# San Francisco International Airport Shoreline Protection Program

BCDC ECRB Meeting  
September 25, 2024

# Agenda

Figure S-1

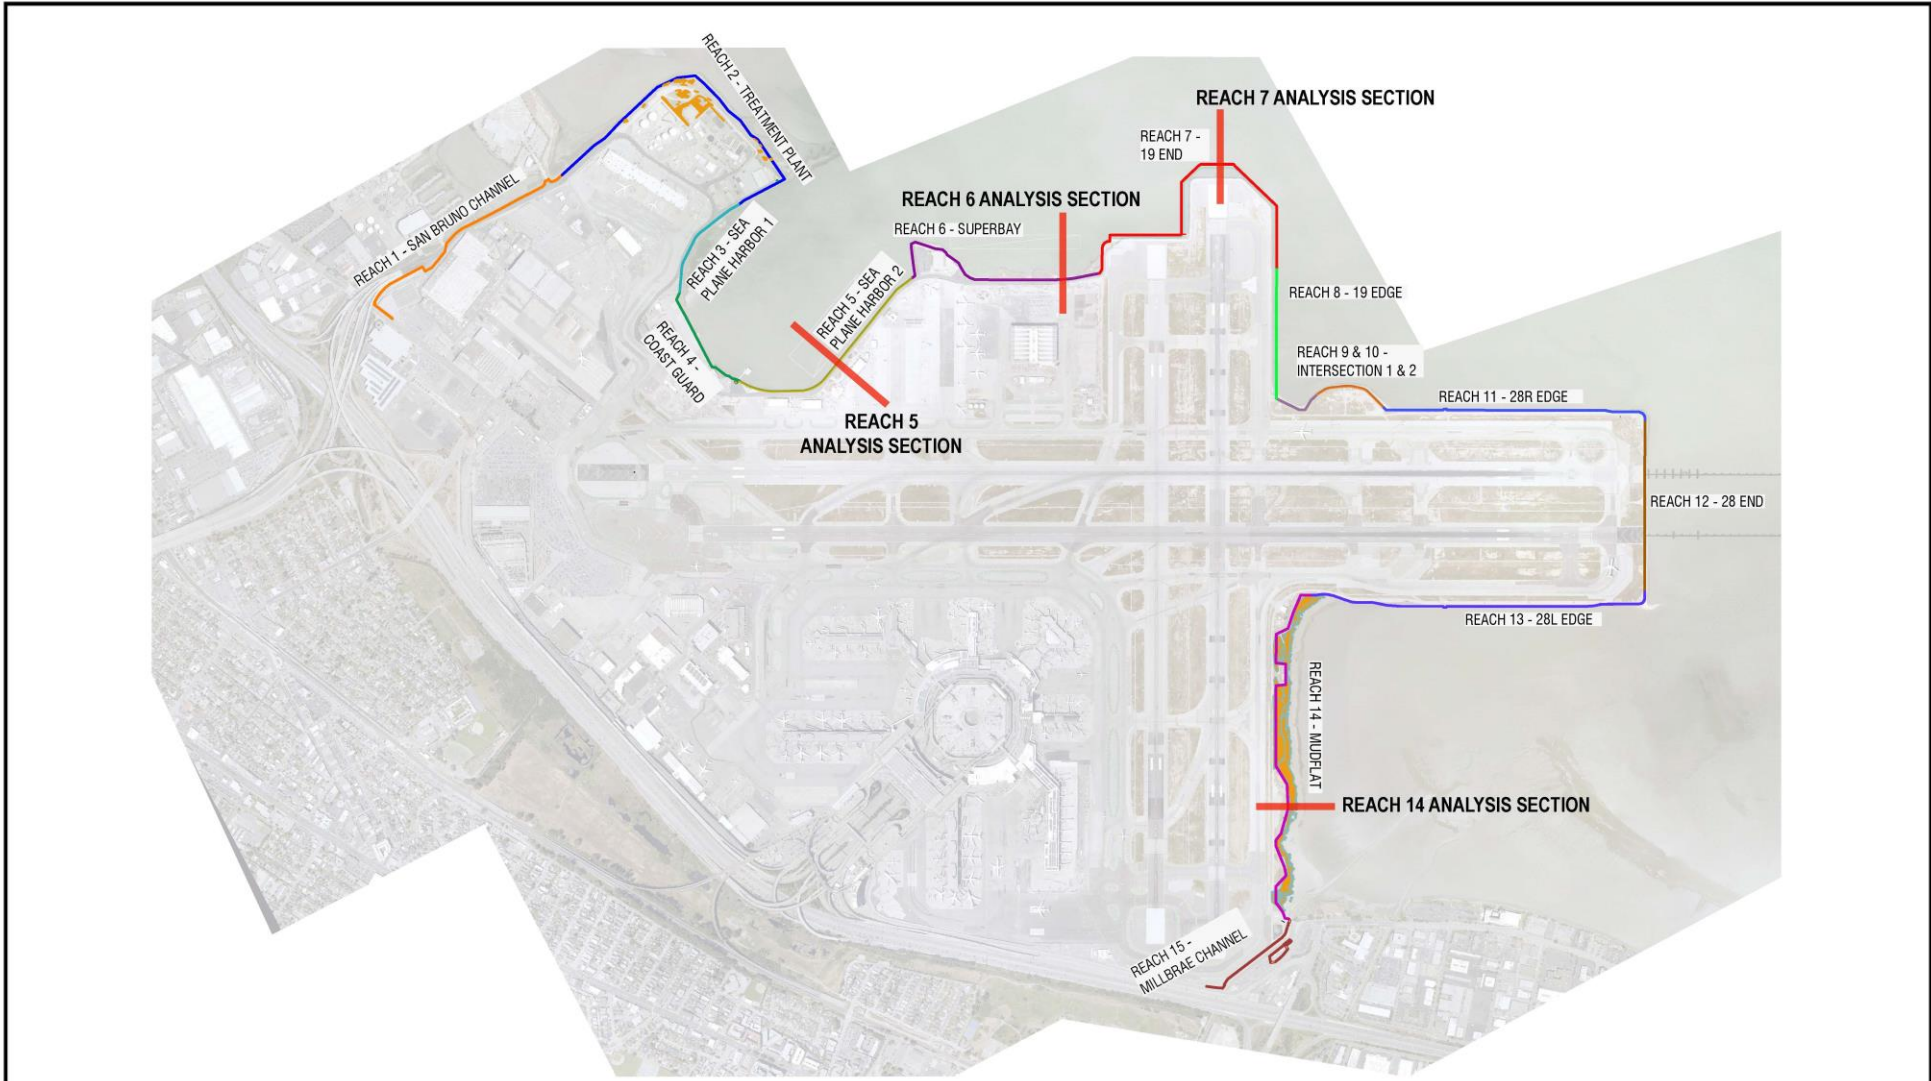
**ECRB-1:** *The 2D PLAXIS modeling of the seismic site response/lateral displacement was done at Reach 6, which was assumed to be a critical area due to the thickest layer of Young Bay Mud (YBM) observed.*

- *This may not be the area with the strongest ground motions; however, thicker YBM can attenuate strong ground motion.*
- *Please perform additional analyses that include other sections to evaluate ground motions for a variety of subsurface profiles, and to evaluate which section(s) may be critical from the perspective of slope stability and seismic performance.*

**TABLE 4.11-1 CORROSION RATES**

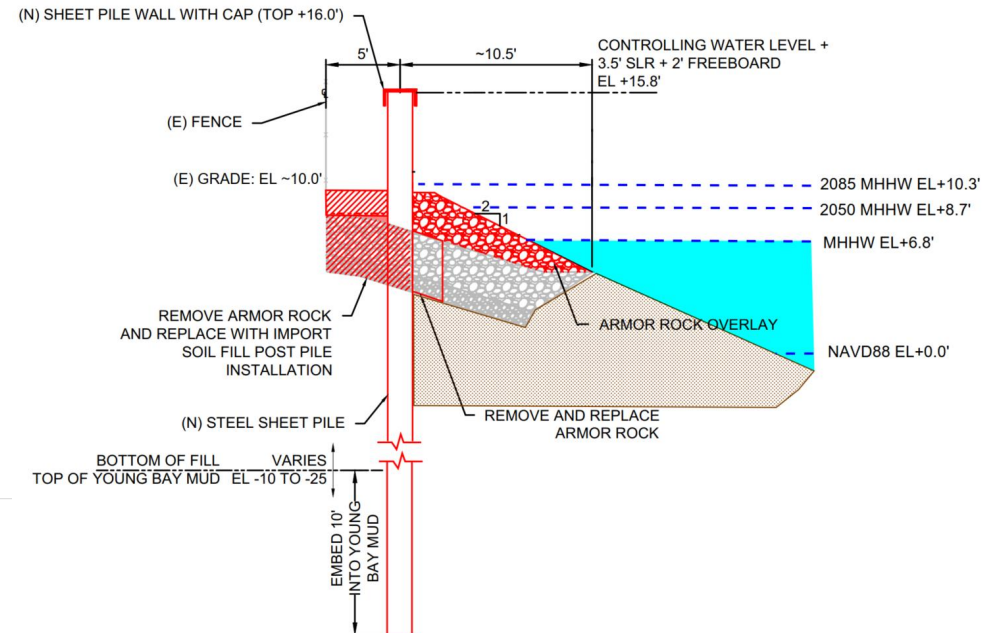
**ECRB-4:** Corrosion is important to address since it can weaken the steel wall. According to the design team, corrosion of the steel sheet piles is being addressed by a coating system. Analysis of corrosion rates in the design to date rely on published numbers when corrosion rates are site specific. Provide a monitoring program to measure actual corrosion rates at the site so coating maintenance can be timed appropriately.

- Wall designed with additional thickness (sacrificial steel) and corrosion coating
- Sheet piles to have 3/8” minimum wall thickness and coated from top to 10 ft below mudline
- All structural analysis done with assumed corroded wall thickness per California DOT Corrosion Guidelines Version 3.2. Design life is 60 years with worst case of 50 years’ corrosion assumed.

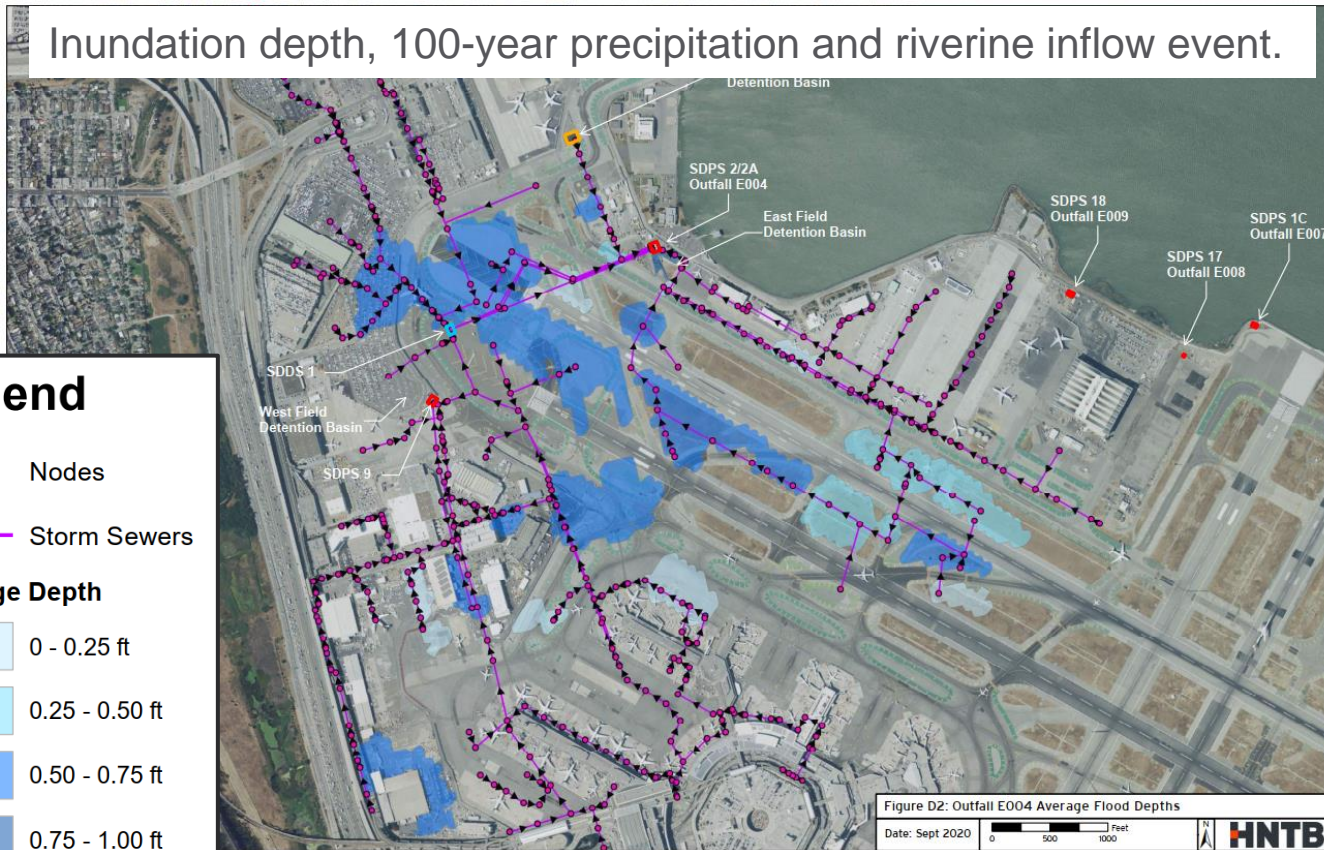
**ECRB-6:** In an emergency event such as a flood or earthquake, the ability for the airport to get back into operation is expected to depend on the operation of the stormwater pumping system. Therefore, provide information on how the pumping system is powered, if backup power is available, and present what measures will be taken to have a resilient stormwater pumping system in the project. At what elevation have the backup power systems been placed (compared to tides and flood levels)?

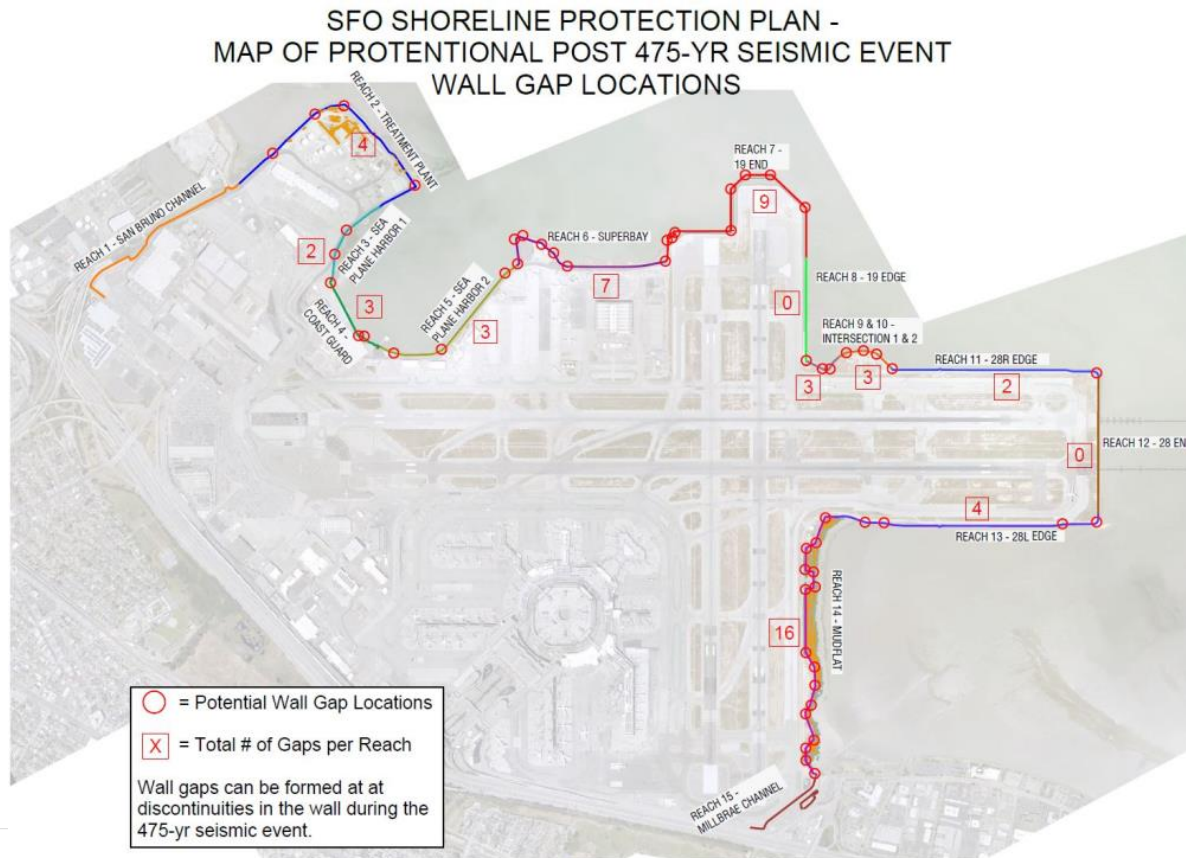
**BCDC-1:** In a future high tide scenario, with all the flood gates deployed, with an earthquake that damages the wall, what is the process and timeline for repairing the sea wall? Will outside contractors need to access the site?

*BCDC-1 (con't): How much water could pour in and, is the existing stormwater pumping system expected to handle it?*

- High Seismic Hazard Level event (475-year) could experience localized damage consisting of gaps forming at wall junctions
- Potential number mapped, by reach (see map)
- Temporary repair: Within one week of an earthquake, close gaps up to 3 ft above the existing grade with sandbags, soil, and/or K-rail
- Permanent repair: Within six months of an earthquake, close gaps to original design elevation with steel plates, new piles, etc.
- Flood gates anticipated to only be needed to block water levels for a few hours
- Temporary repair may involve SFO and/or outside contractor. Permanent repairs likely to involve outside contractor.

**TABLE 3 - CLOSURES**

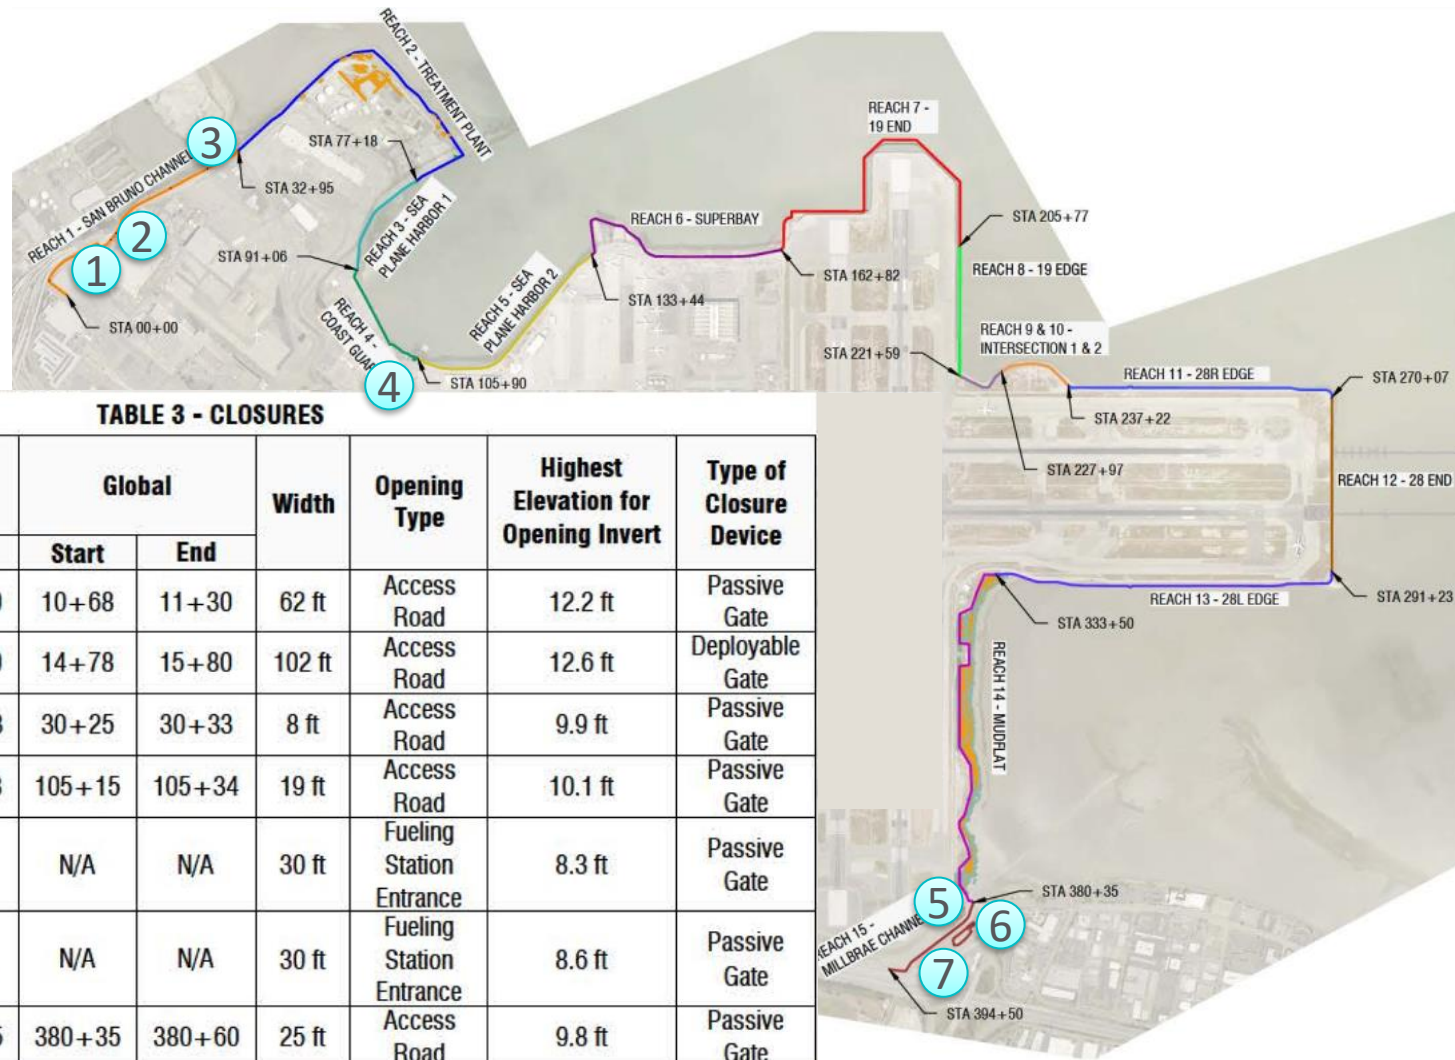
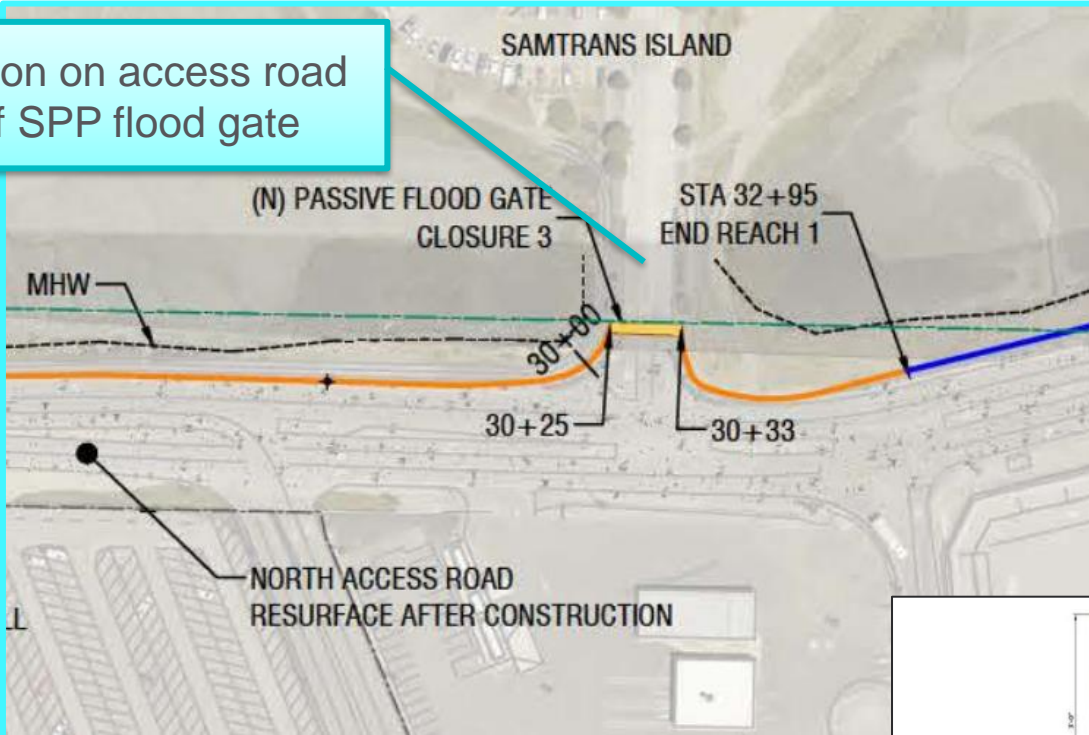
*BCDC-2: During the life of the project, how frequently do you expect the passive flood gates and deployable flood gate to be up? Please provide proposed grades at each flood gate.*

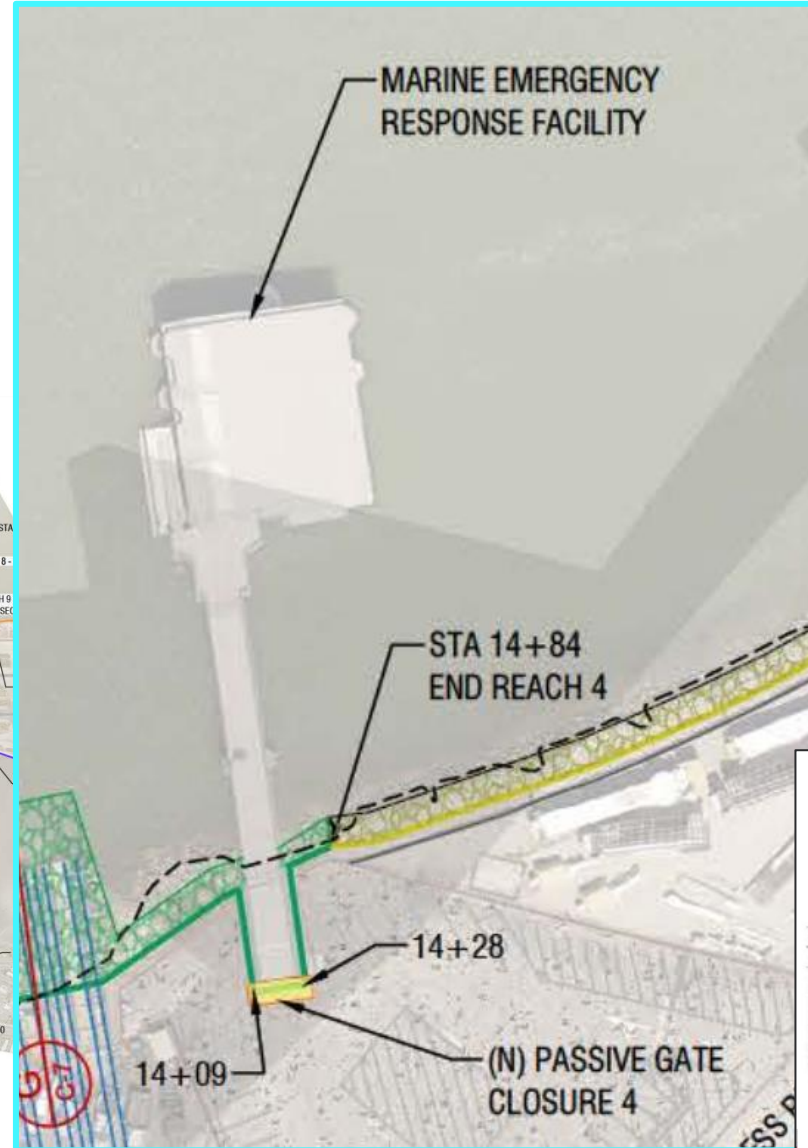
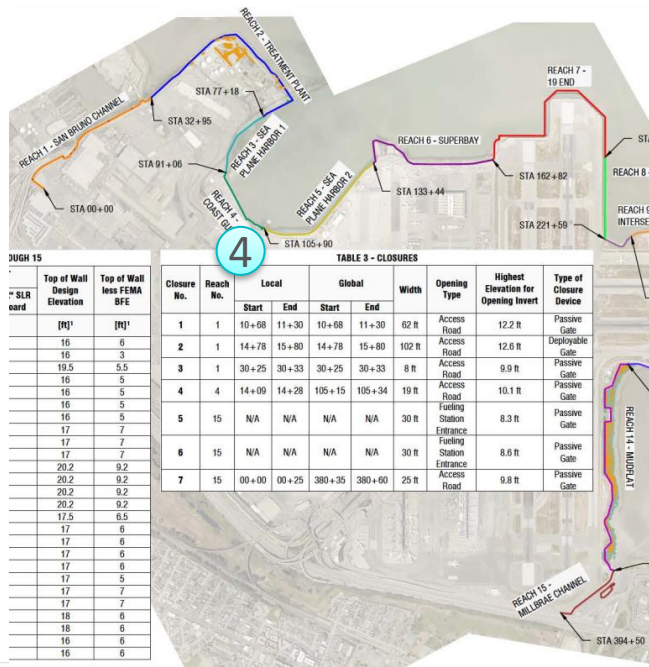
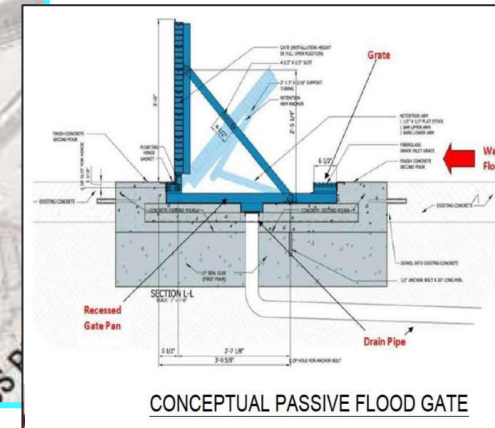
**BCDC-3:** What is the Marine Emergency Response facility in Reach 4 and is there an issue with it being inaccessible when the passive gate is up between it and the airport?

The MERF is an over-water facility to store marine rescue vehicles

**Invert = 10.1 ft NAVD88**

SLR, ft	MHHW freeboard, ft	1% SWL Freeboard, ft
0	3.3	-0.2
1.5	1.8	-1.7
3.5	-0.2	-3.7

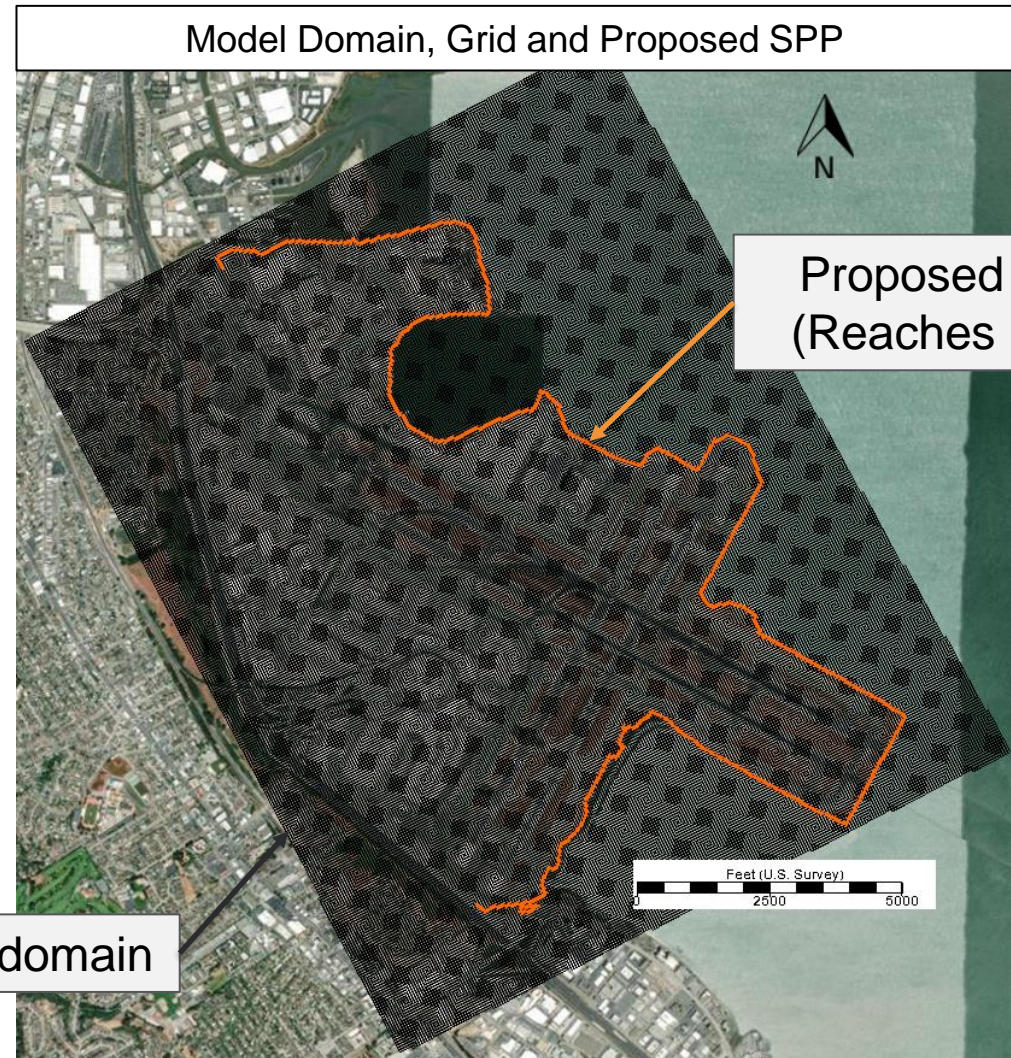
*ECRB-8: Do you expect the new sheet pile wall to raise groundwater levels onsite during storms, exacerbating flooding risk? Provide a quantitative study or rationale to justify your conclusion.*
